D868UV firmware update V1.16 and V2.16

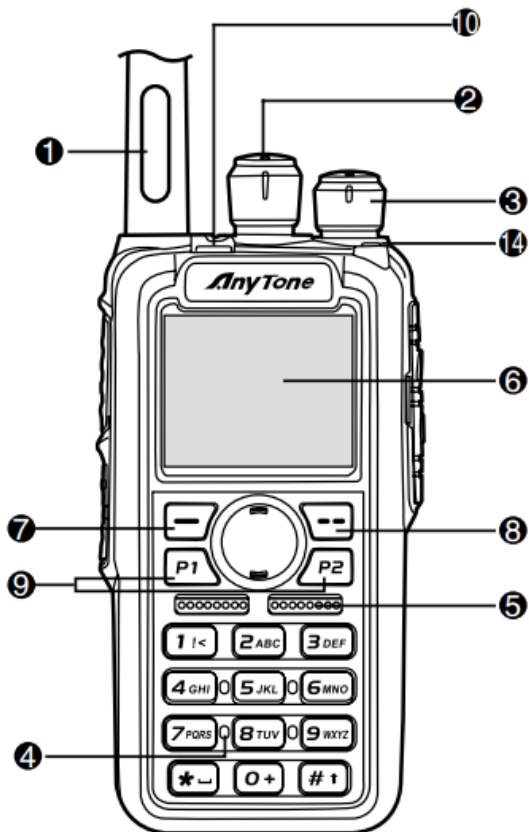
1. Allow the frequency input 144.783750MHz
2. Make the fields length all 16characters.

Zone names

Channel names

Scan list names

Receive Group List name

Analog Address Book name

Talk Group Name and City
